**UNITED STATES  
NUCLEAR REGULATORY COMMISSION**  
WASHINGTON, D.C. 20555-0001

**SUBJECT:** TECHNICAL ASSISTANCE REQUEST REGARDING THE  
RADIOLOGICAL ASSESSMENT FOR THE CABOT - REVERE,  
PENNSYLVANIA SITE

# **Radiological Assessment for Cabot Corporation Revere, PA Site**

## **Technical Evaluation Report**

**Figure 1.** Generalized conceptual model used in the Cabot-Revere assessment.

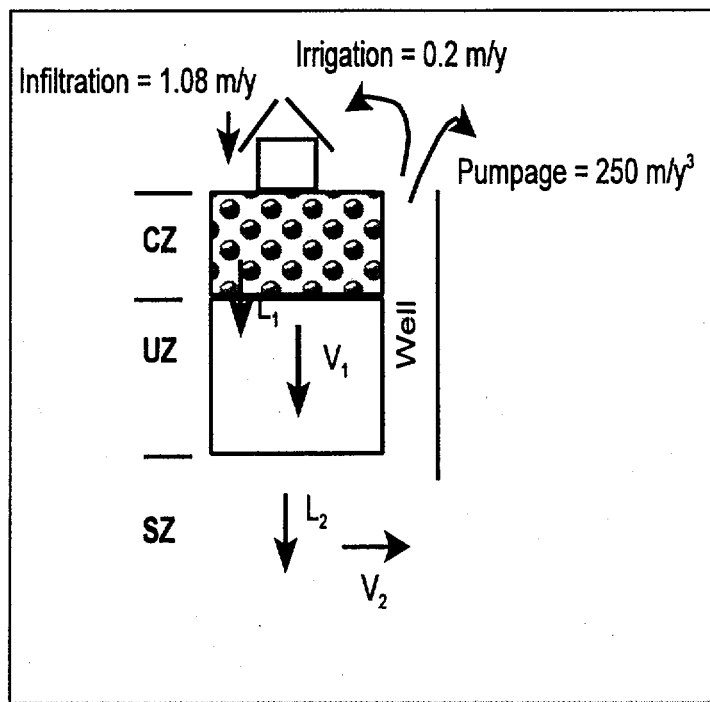
Figure 1 shows a schematic of the general conceptual model used in the Cabot-Revere radiological assessment, based upon staff's interpretation of the information presented in the report.

It should be noted that a default irrigation rate of 0.2 m/y was used in the analysis although the licensee only assumed irrigation as part of their residential gardener scenario.

Based on regional information, the unsaturated zone is believed to be roughly 20 meters thick; however, for the assessment nominal credit is taken for the possible hold-up of contaminants migrating through the unsaturated zone. This is reflected by the small unsaturated zone thickness (0.01 m) assumed for the analysis. Staff believes that this adds conservatism to the calculated doses for the water-dependent pathways.
